MIL-PRF-83536/6
AMENDMENT 4
10 July 1999
SUPERSEDING
AMENDMENT 3
15 December 1998

PERFORMANCE SPECIFICATION SHEET

RELAYS, ELECTROMAGNETIC, ESTABLISHED RELIABILITY, 4PDT,
LOW LEVEL TO 5 AMPERES, PERMANENT MAGNET DRIVE, HERMETICALLY SEALED,
ALL WELDED, TRANSIENT SUPPRESSED DC COILS

CIRCUIT DIAGRAM (NO MOUNT, RVFM, HFH AND TRACK MOUNT A)
(OPTIONAL INTERNAL DIODE CONFIGURATION)

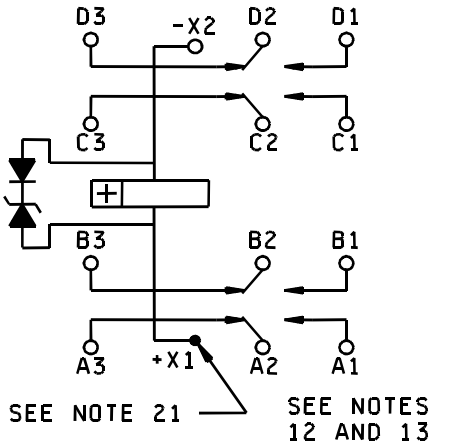
Add the following circuit diagram:
